LUSCOMBE AIRPLANE CORPORATION
DALLAS 1, TEXAS

SERVICE BULLETIN NUMBER 3-46

SUBJECT: Installation of Rudder Return Springs, Model 8A
Serial Numbers 1925-3049

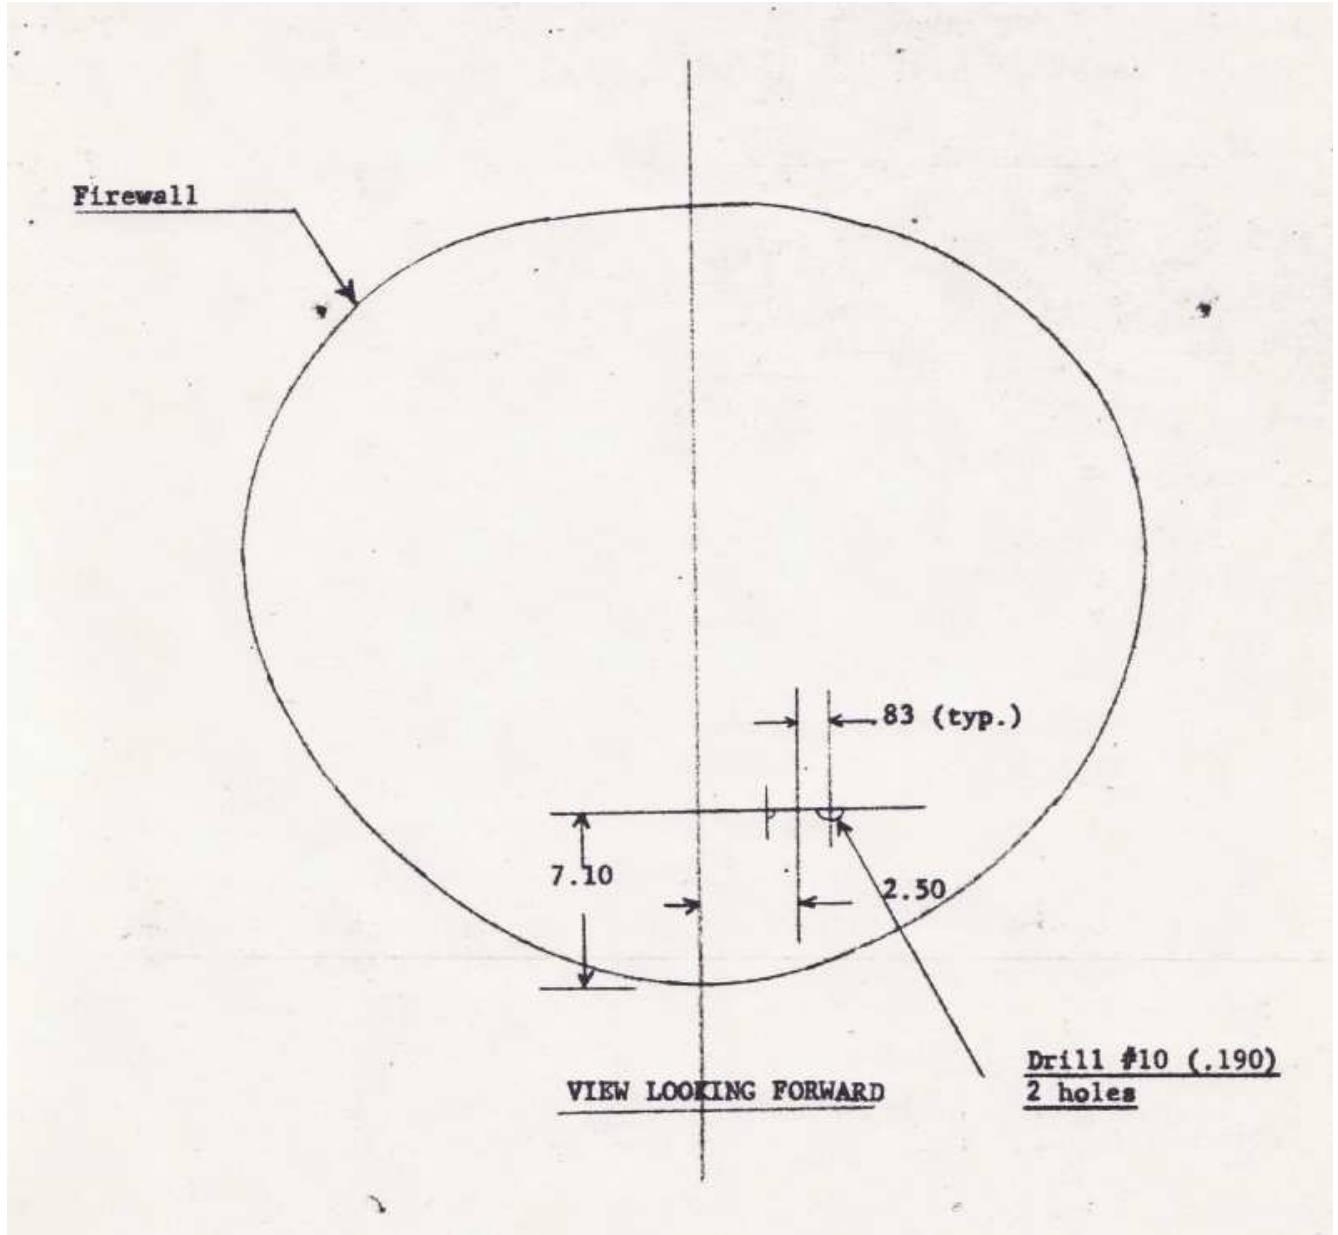
In order to improve the directional stability characteristics of the Model 8A airplane, the changes described below and illustrated in the accompanying drawings are to be made as soon as possible.

1. Drill two #10 (.190) holes in firewall, located as per sketch.
2. Drill one #30 (.1285) hole in each rudder control horn, located as per sketch.
3. Install springs between firewall and rudder control horns, using AN42-6 bolts for connection springs to firewall. The spring tension may be varied slightly by carrying the arrangement of the washers on either side of the firewall until the rudder is held perfectly neutral by the springs.

NOTE: that the left spring is installed with a 1" steel link between the spring and the firewall.
